Monthly Specification Update

Intel® Server Board S3420GP

Intel Order Number E82362-007

July 2011

19. Intel® Server Board S3420GPRX may have high CPU utilization when installing or running Microsoft* Windows Server 2008 R2* or Microsoft Windows 7* with OS default embedded NIC driver

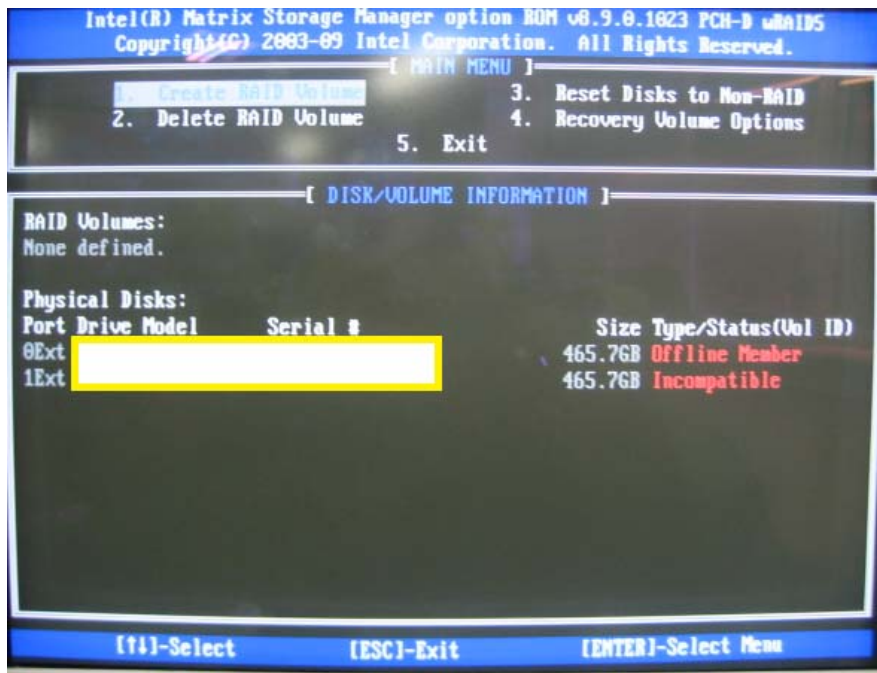
Problem	There has been high CPU load observed when installing or running Microsoft Windows Server 2008 R2* or Microsoft Windows 7* with OS default embedded NIC (Network Interface Card).
Implication	When the ports are not electrically “linked” and the embedded driver is loaded the DPC rate steadily increases until the system slows to the point where it is essentially unusable.

Status	This issue was fixed in BIOS 0047. Before Operation System installation, change the BIOS setting under Advanced → PCI Configuration → PCIe AER support from Enable to Disable .
Workaround	Make sure the ports are connected to a network, switch or simply back-to-back. This need to be done at least prior to the driver loading because once the port is malfunctioning, it cannot be recovered by connecting the ports. Updating to the latest posted driver can resolve the problem. The latest NIC driver can be obtained at the followingweb page: http://downloadcenter.intel.com/Detail_Desc.aspx?agr=Y&DwnldID=18388 .

6. Intel® Server Board S3420GP Quick Start User Guide update for the processor socket protective cover change

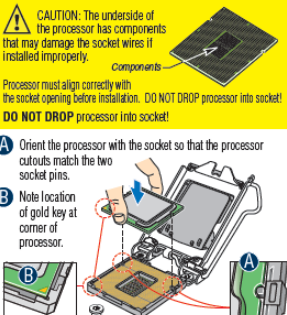
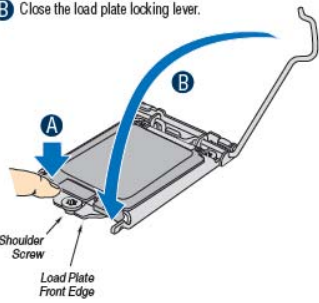
Implication To reflect the processor socket protective cover change, the following step will be the post-change installation procedure.

A Orient the processor with the socket so that the processor cutouts match the two socket pins.

A Make sure the front edge of the load plate slides under the shoulder screw as the lever is lowered.

B Close the load plate locking lever.
